Staff Report

Infill Housing Design Review Committee

File Number: 6-G-21-IH

Location: 222 Atlantic Ave. **Parcel ID** 81 G B 005 01
Zoning: RN-2 (Single-Family Residential Neighborhood)
District: Oakwood/Lincoln Park Infill Housing Overlay District

PLOT PLAN OF:
LINWOOD SECOND ADDITION
 LOT 6 - BLOCK J
222 Atlantic Ave
Knoxville, Tennessee 37917

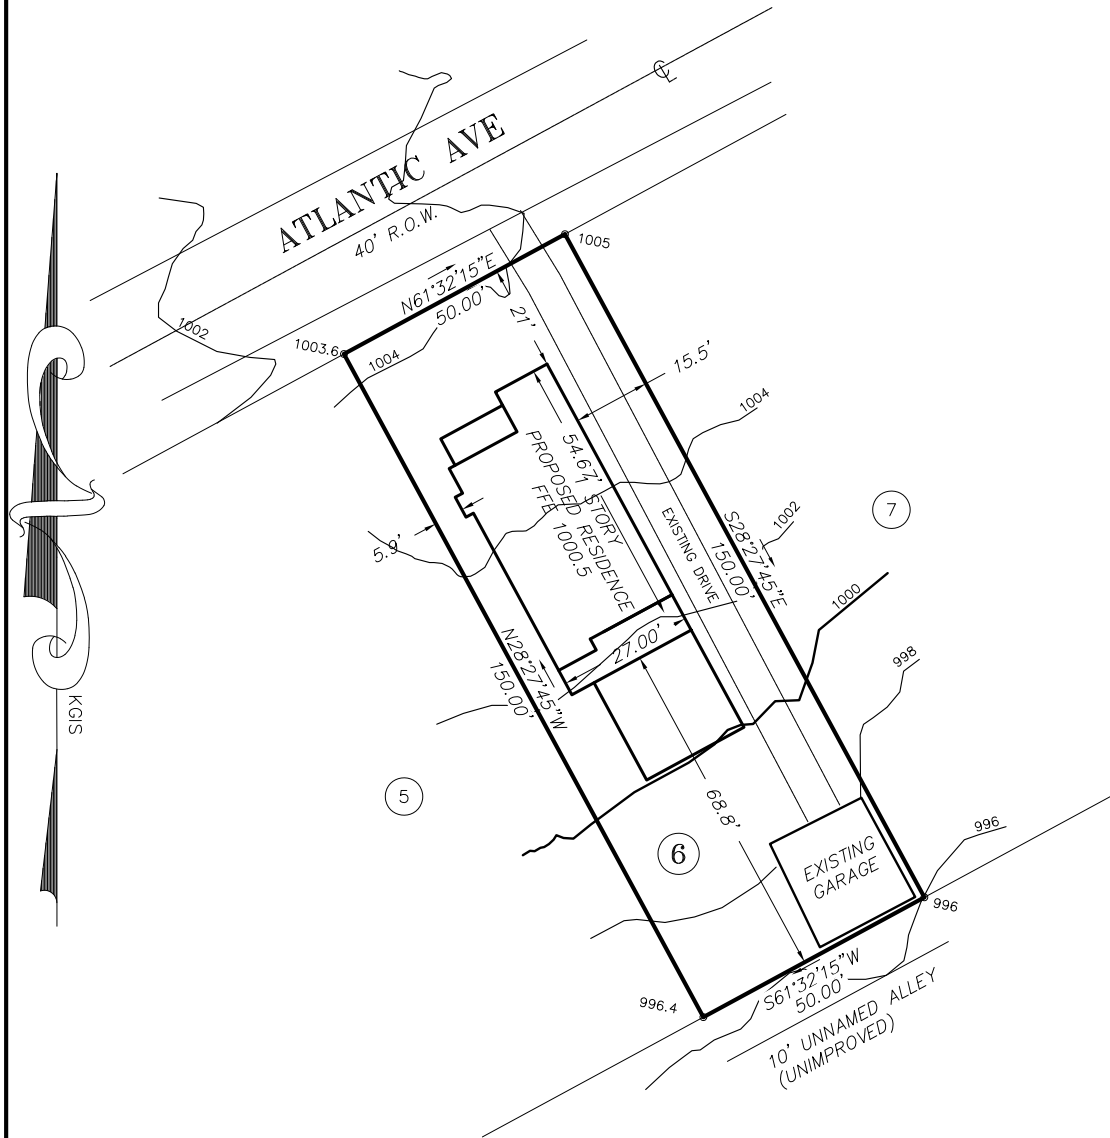
1. The house is proposed to be located 21' from the front property line. The block has a somewhat irregular front yard pattern, with the adjacent property (218 Atlantic) recessed towards the rear property line; the average front setback of the block is 30'. The proposed front setback should be verified to be consistent with historic properties on the block. The final site plan should include a walkway from the front door to the street.

3. The proposed parking meets Infill Housing design guidelines as the alley is unimproved, and the proposal uses an existing driveway extending off Atlantic Avenue. The driveway extends the full length of the lot towards an existing garage at the rear, so the parking spots will be located at least 20' beyond the front façade of the house. The final site plan and parking may need minor modifications to meet City Engineering standards.

9. Final site plan should show a native or naturalized shade tree to be planted in both the front and rear yards.

- 1) Confirm front setback's consistency with historic houses on the block; if necessary, move the house slightly towards the rear property line, with approval by staff;
- 2) Include a walkway from the street to the front door;

- 3) Use horizontal lap siding with an overlap instead of board-and-batten or Dutch lap;
- 4) Final drawings and site plan to omit rear carport;
- 5) Final site plan and parking to meet City Engineering standards;
- 6) Final site plan should include a native or naturalized shade tree in both rear and front yards.

403 RIGHT VIEW SCALE 1/4" = 1'-0"

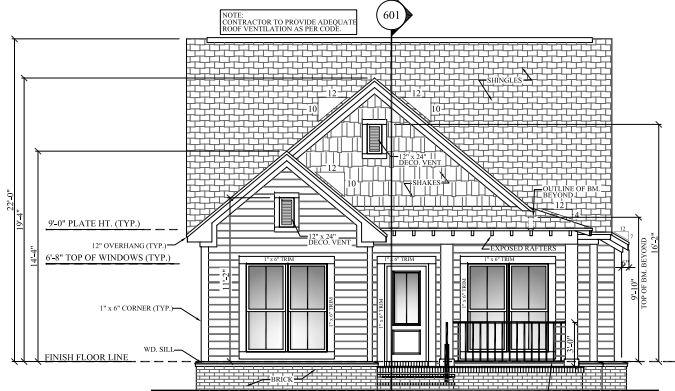
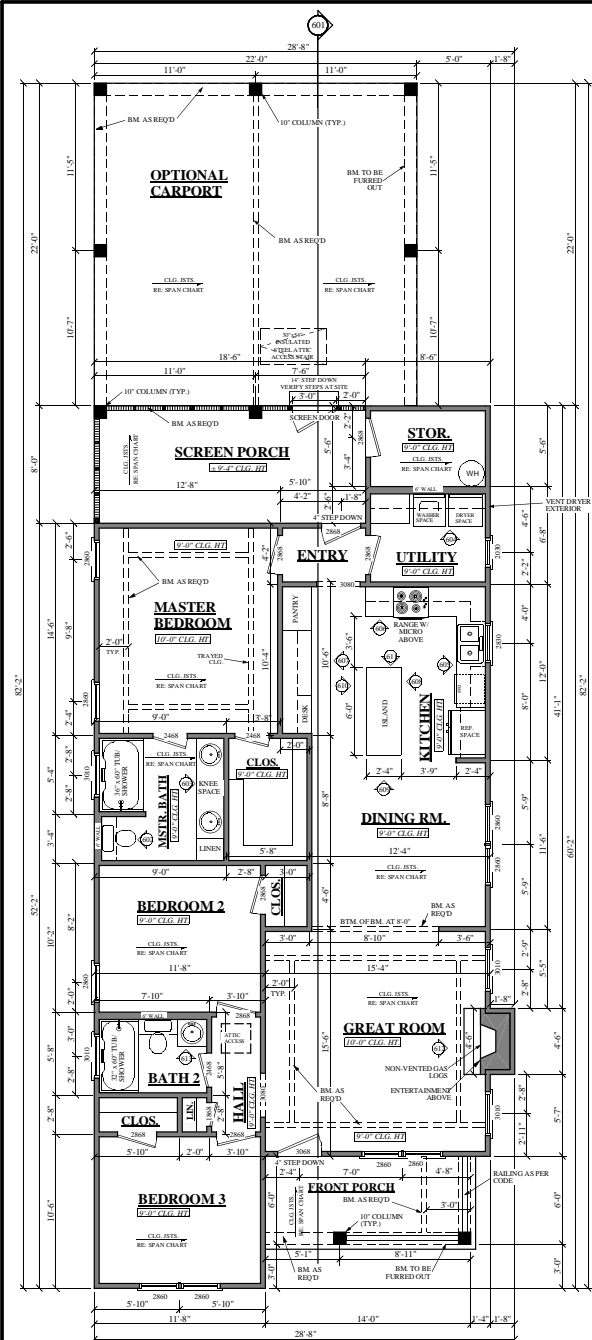
6. Guidelines recommend window and door styles be similar, with similar proportions and similar ratio of solid to void, to historic houses on the block. Overall, the house design includes a significant number of exterior windows on the façade and side elevations. The Board may choose to discuss the right side elevation, where two fixed transom windows flank a unique shed-roof massing with no transparency. The proposal includes well-detailed window and door trim.

7. The roof pitch and materials are appropriate within the design guidelines.
8. Guidelines note that "clapboard-like siding should be used" on new houses in neighborhoods where wood lap siding was traditionally used. Board-and-batten siding is not a common historic siding material in Knoxville; horizontal lap siding with an overlap should be selected to match elevation drawings (rendering shows board-and-batten).
